# UNITED STATES PATENT AND TRADEMARK OFFICE

10/613,513

<b>Office Action Summary</b>	<b>Application No.</b> 10/613,513	<b>Applicant(s)</b> LIM ET AL.	
	<b>Examiner</b> M. Alexandra Elve	<b>Art Unit</b> 3742

### **DETAILED ACTION**

Figure 1B Dai et al. (WO 02/081366A1) shows localized heating zones (8) with multiple heating prongs or laser beam prongs.

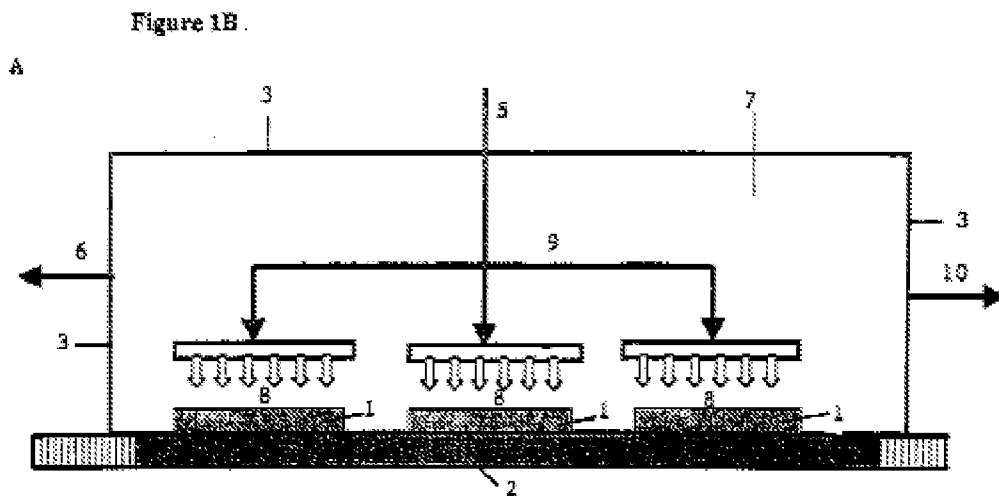
beam. Temperatures range from 300 to 800°C. Localized heating zones (8) have multiple prongs, as shown in figure 1B below:

It would have obvious to one of ordinary skill in the art at the time of the invention to modify Colbert et al. to use multiple prongs for heating as taught by Dai et al. because it ensures even heating and hence uniform nanotube formation.
